## ADDENDUM TO IFB

IFB Number: IFB 17-024/JW  
IFB Title: Taxiway D Reconstruction (2017) at Jack Brooks Regional Airport  
IFB Due: **11:00 am CDT, Tuesday, August 8, 2017**  
Addendum No.: 3  
Issued (Date): August 4, 2017

### **Reason for Issuance of this Addendum: Extending the Construction Schedule, and Changing the Method of Measurement for P-152 Material.**

TAXIWAY D RECONSTRUCTION (2017)

DRAWING NUMBER  
**G-301**

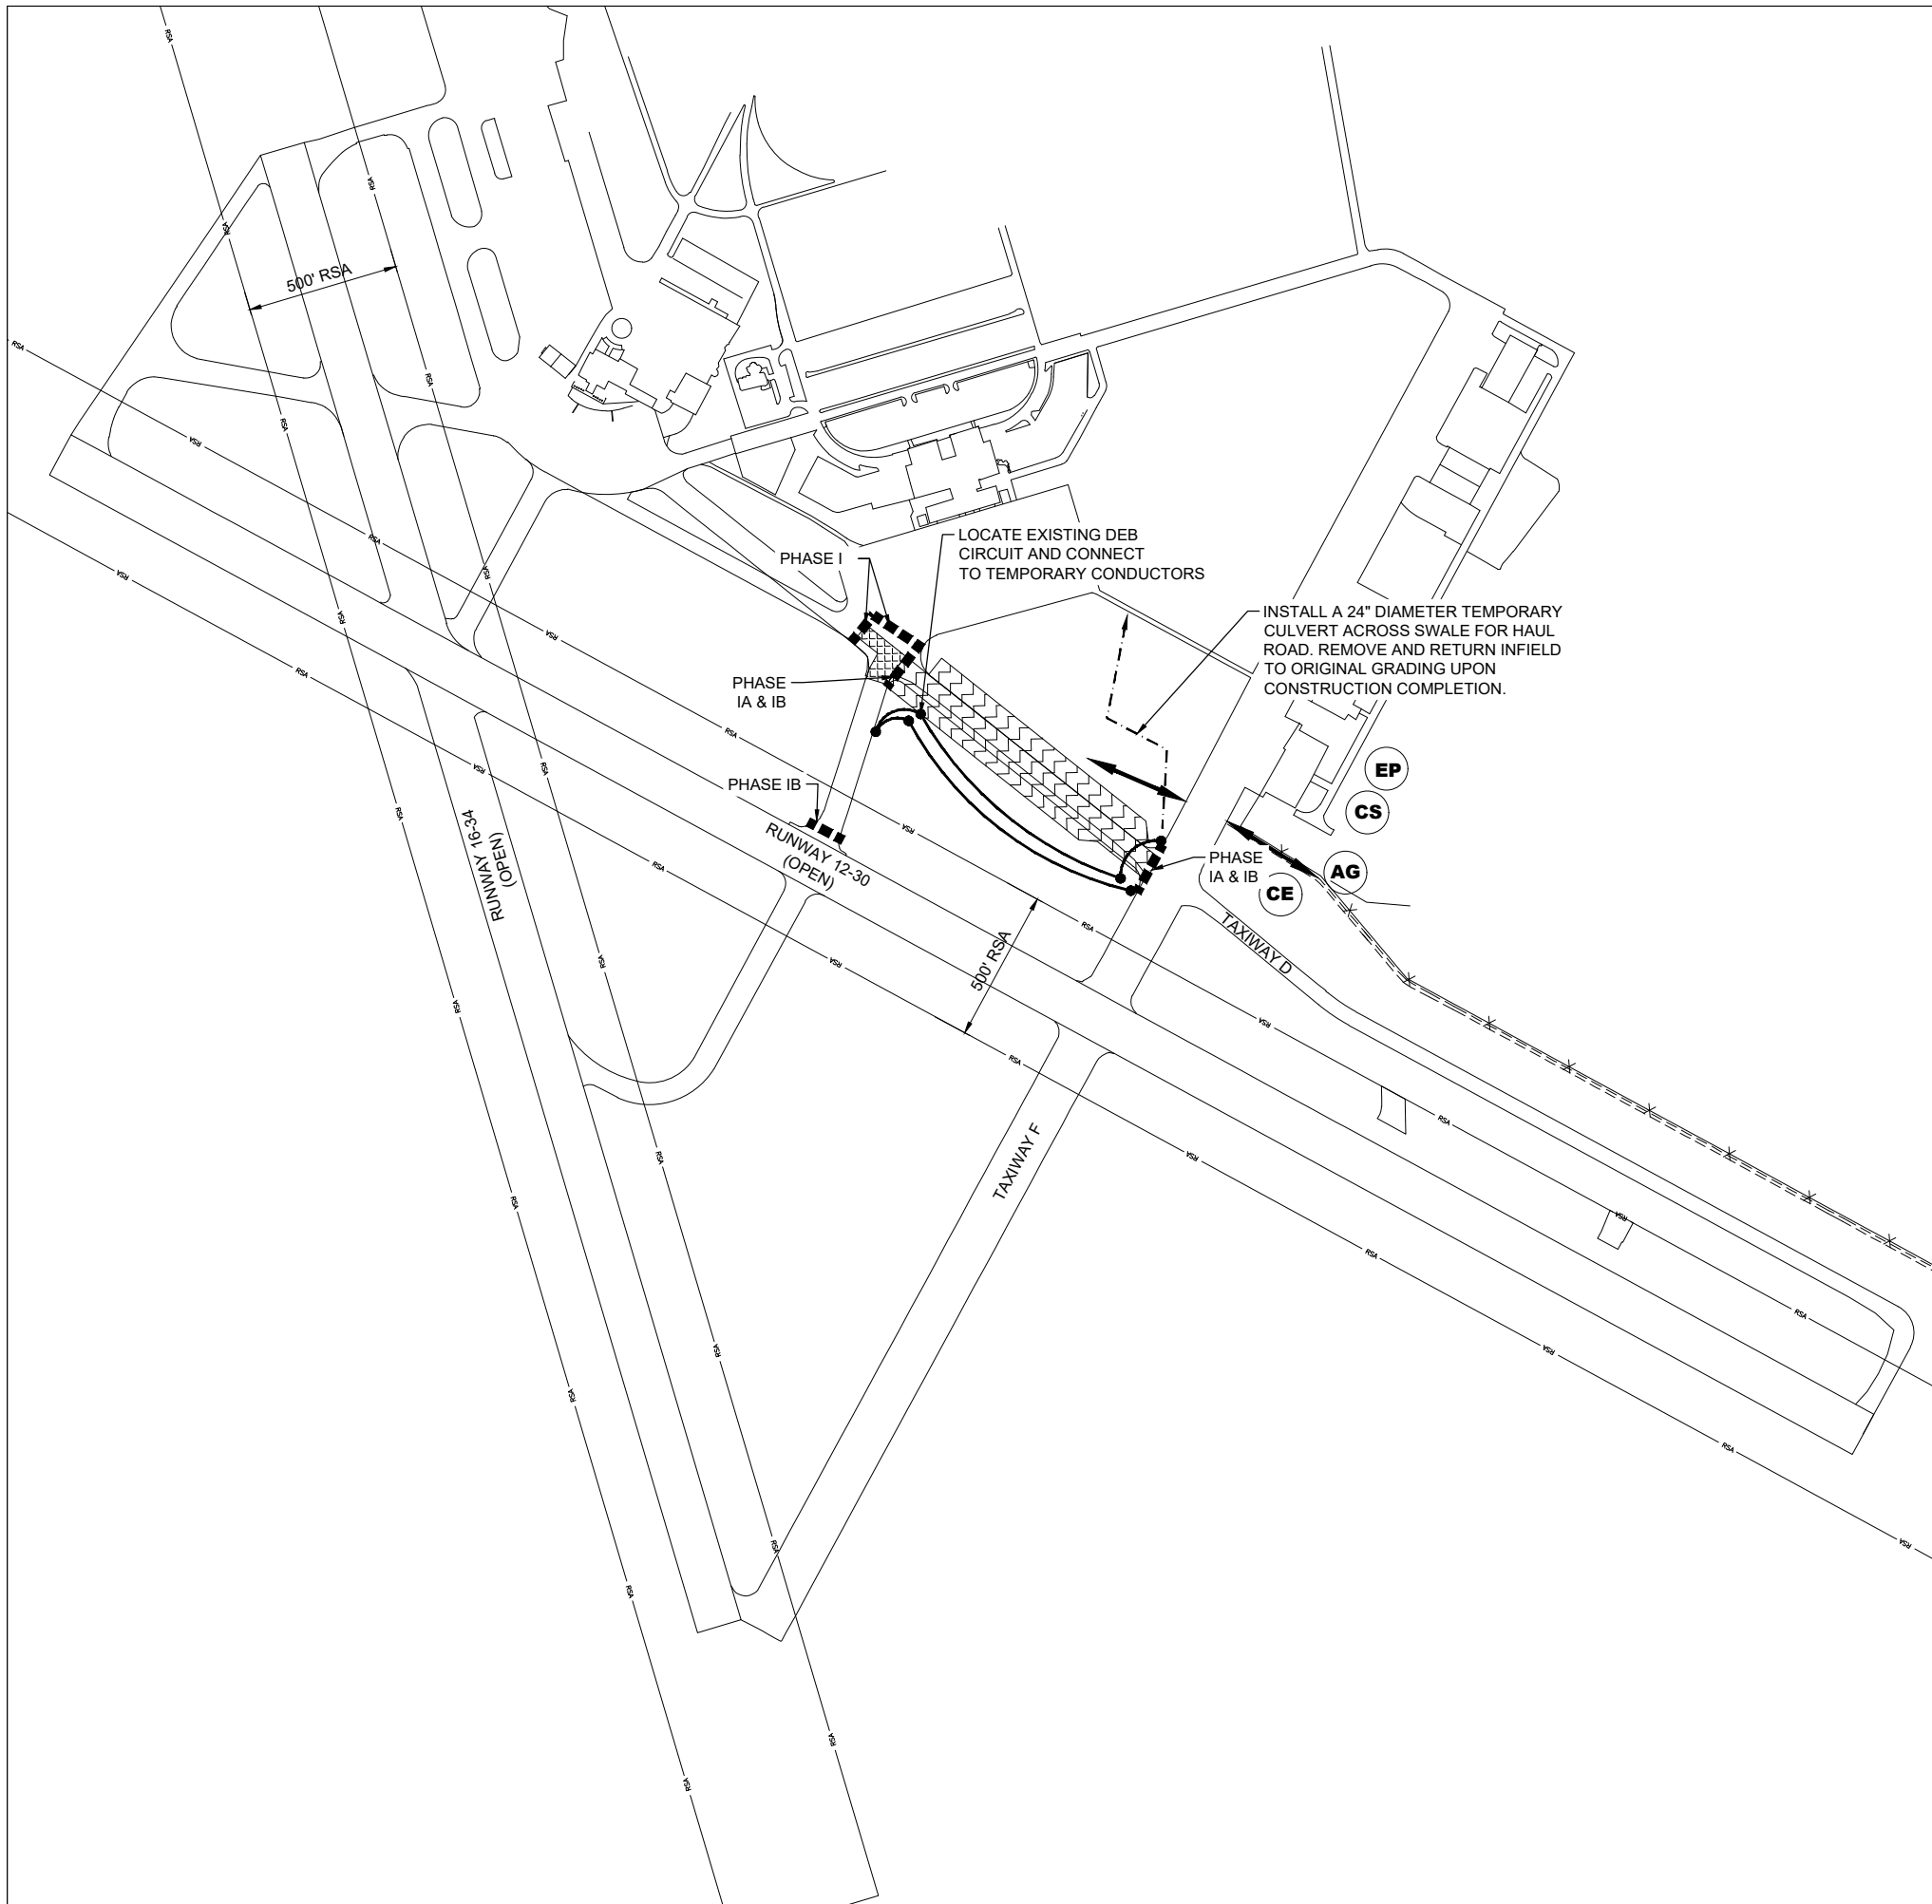
The construction schedule has been extended from 274 calendar days to 359 calendar days. Please find attached the updated Construction Safety and Phasing sheets from the construction drawings reflecting the new phase durations. The project manual has also been edited to reflect the new schedule. The following project manual sections reference the construction duration and have therefore been updated and included in this addendum: The Template Notice to Proceed; The Bid Form; The Contract.
